Attachment Ia
Marked-up Technical Specification Pages
Catawba

Attachment Ib
Marked-up Technical Specification Pages
McGuire

Attachment II
Justification and Safety Analysis

Figure 2.1-1 Reactor Core Safety Limits -
Four Loops in Operation

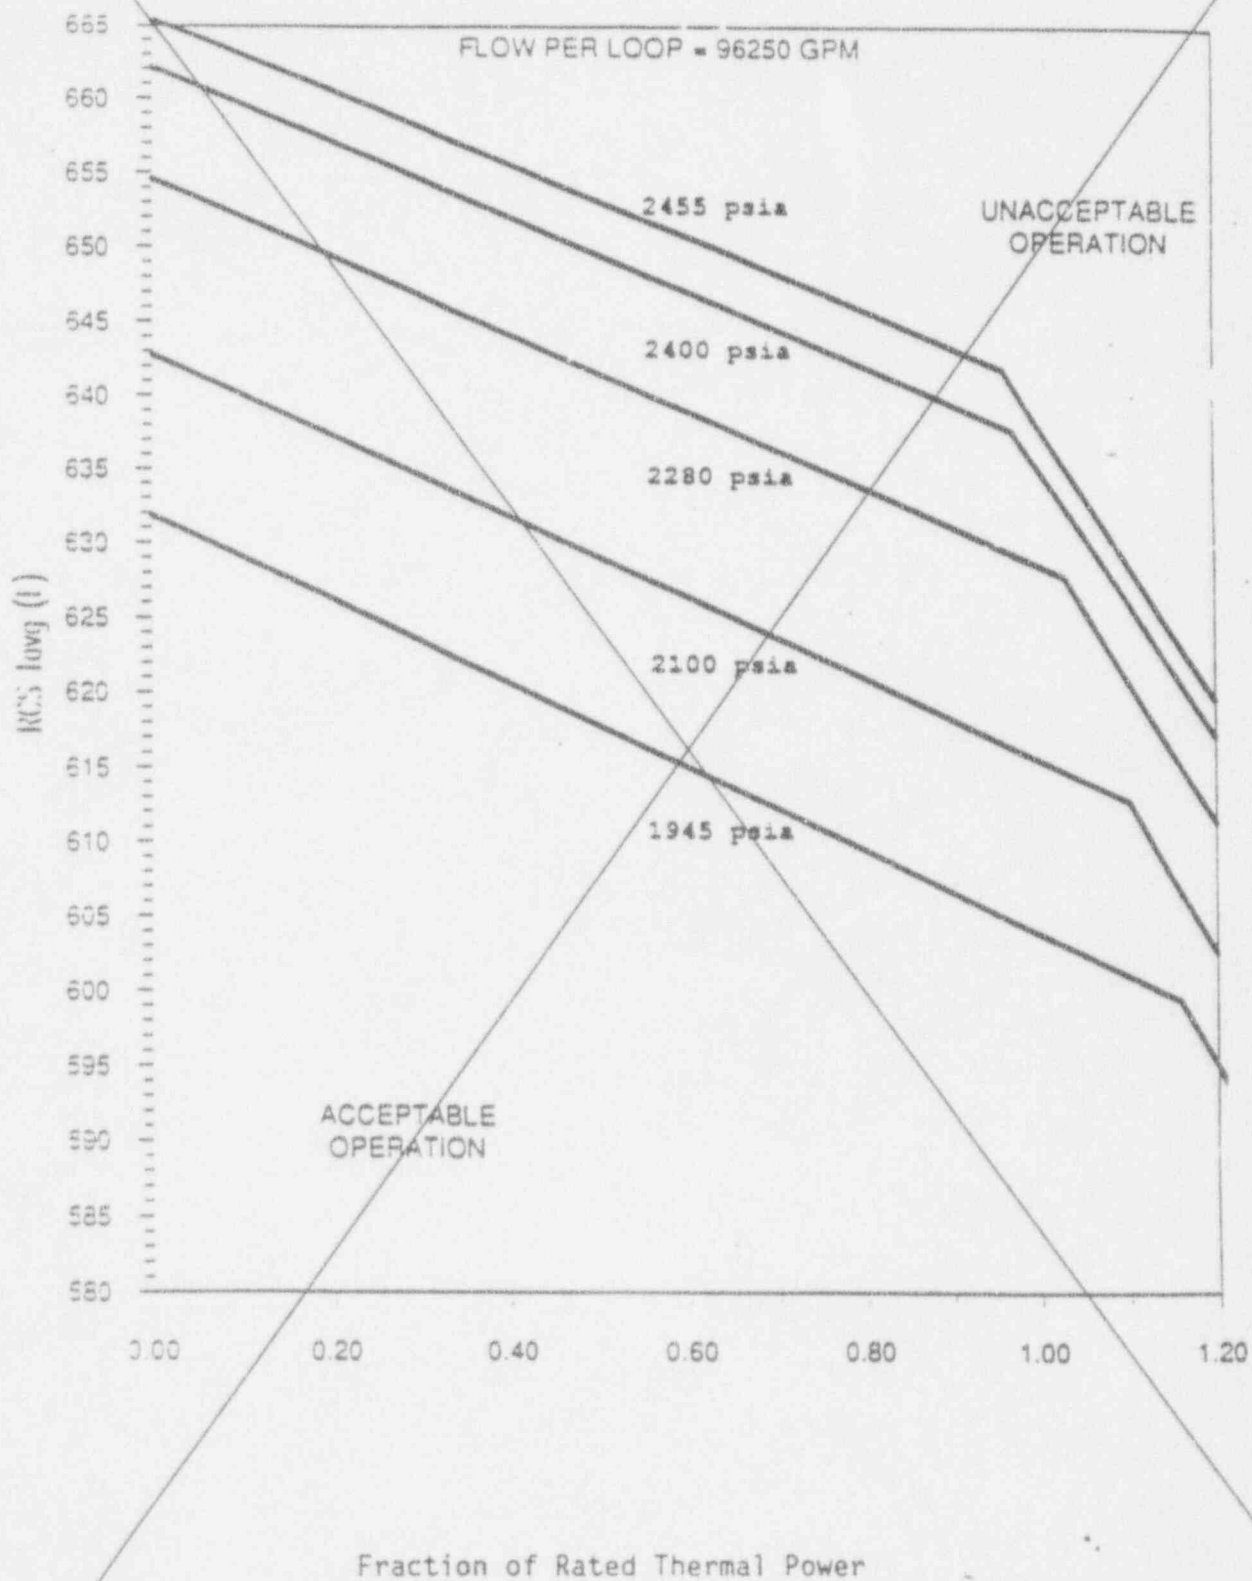
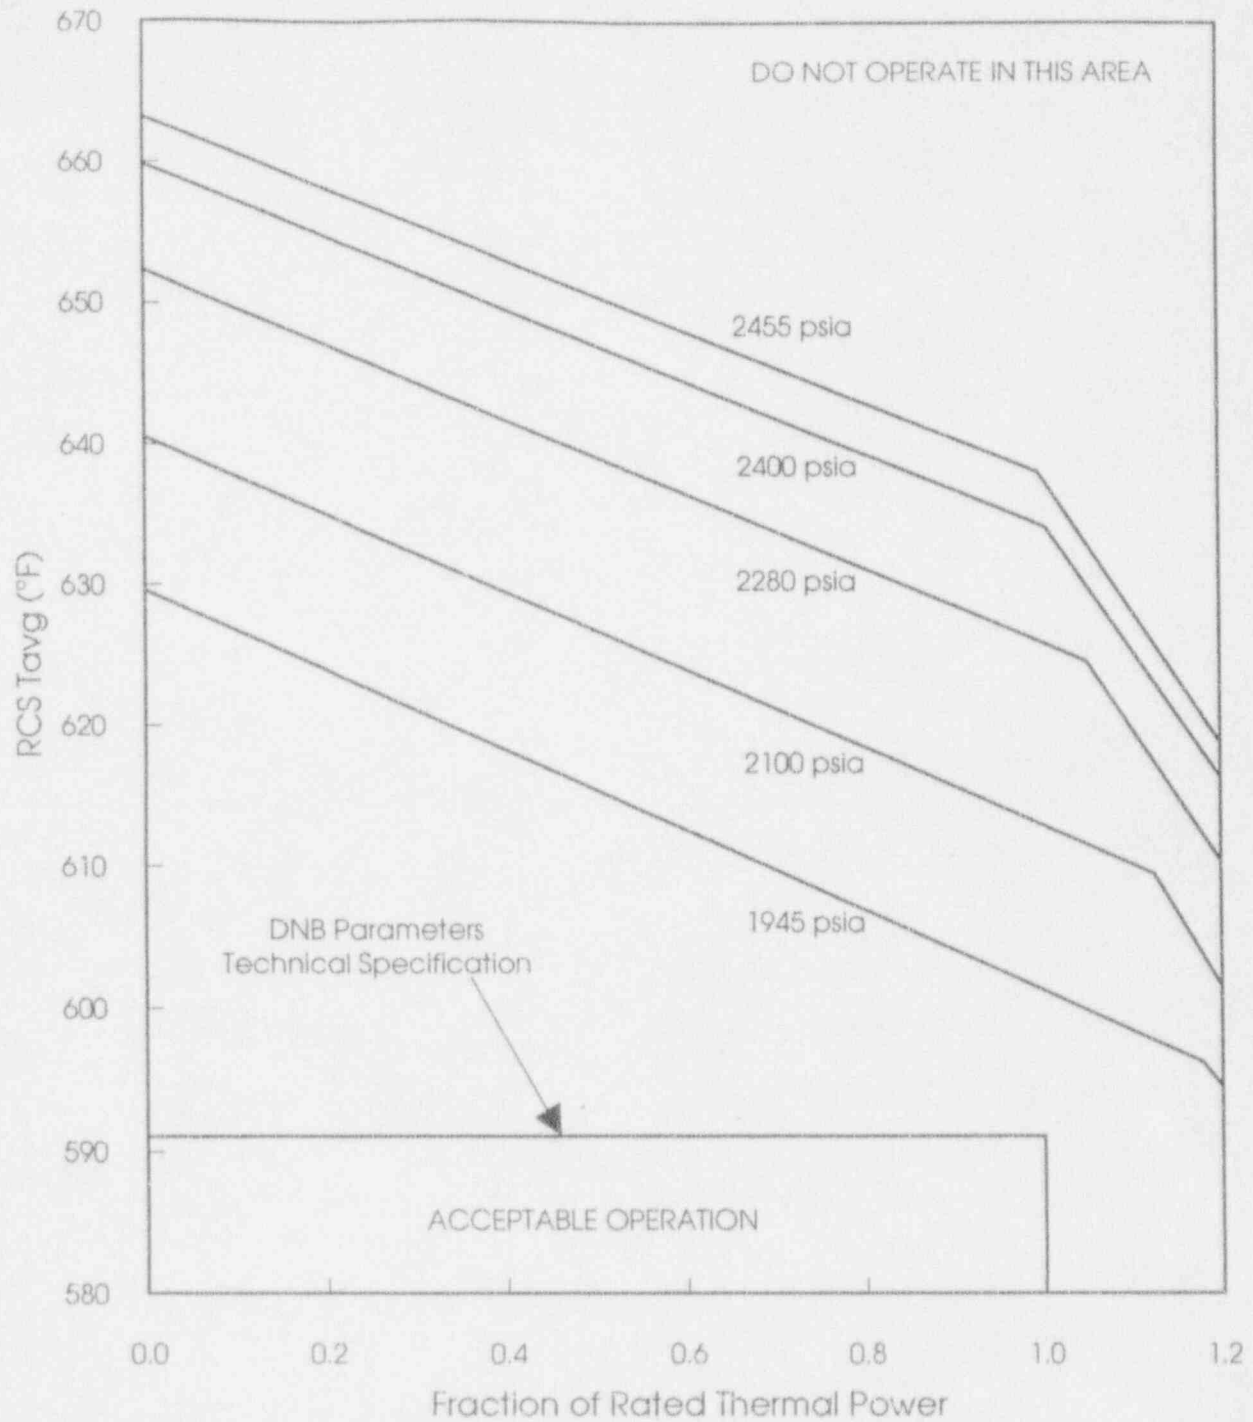
REPLACE

are more restrictive than the actual safety limits.
The curves of Figure 2.1-1 ~~show the loci of points of THERMAL POWER, Reactor Coolant System pressure, and average temperature below which the calculated DNBR is no less than the design DNBR value or the average enthalpy at the vessel exit is less than the enthalpy of saturated liquid.~~

Figure 2.1-1
REACTOR CORE PROTECTION LIMITS - FOUR LOOPS IN OPERATION

Figure 3.2 - 1. Reactor Coolant System Total Flow Rate Versus Rated Thermal Power - Four Loops in Operation

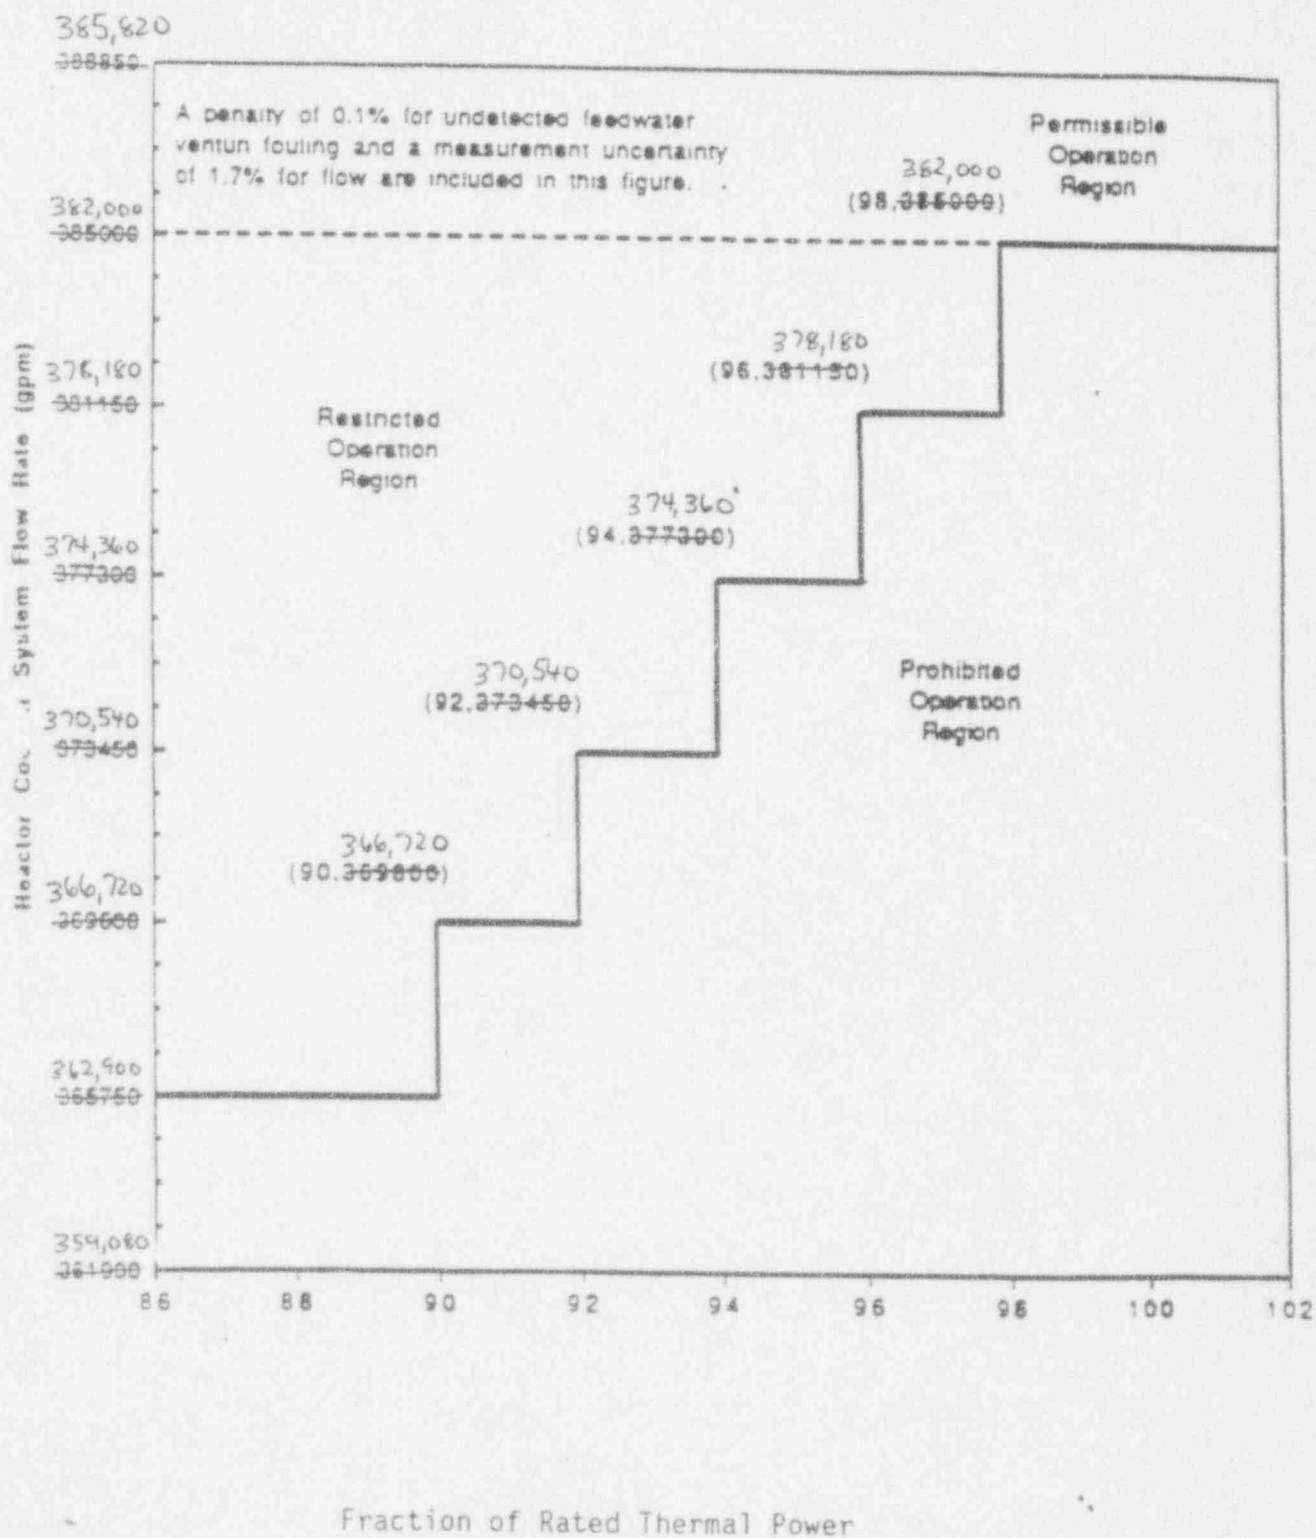
To alleviate this concern, analyses have been performed to justify reduction in the minimum RCS flow to 382,000 gpm. These analyses show that the reduced flow rate will not have a significant impact on any accident analyses presented in Chapters 3, 4, 6, or 15 of the Final Safety Analysis Report (FSAR).

The thermal hydraulic design for the McGuire and Catawba units was analyzed with the reduction in RCS minimum measured flow (MMF) to 382,000 gpm. The reduced flow rate resulted in a slight reduction of the margin in the core DNB limits. Technical Specification Figure 3.2-1, Reactor Coolant System Total Flow Rate Versus Rated Thermal Power - Four Loops In Operation, was revised to reflect the lower allowable flow rate. The Axial Flux Difference limits, Technical Specification Section 3.2.1, are unchanged and all of the current thermal hydraulic design criteria are satisfied at the reduced flow conditions.
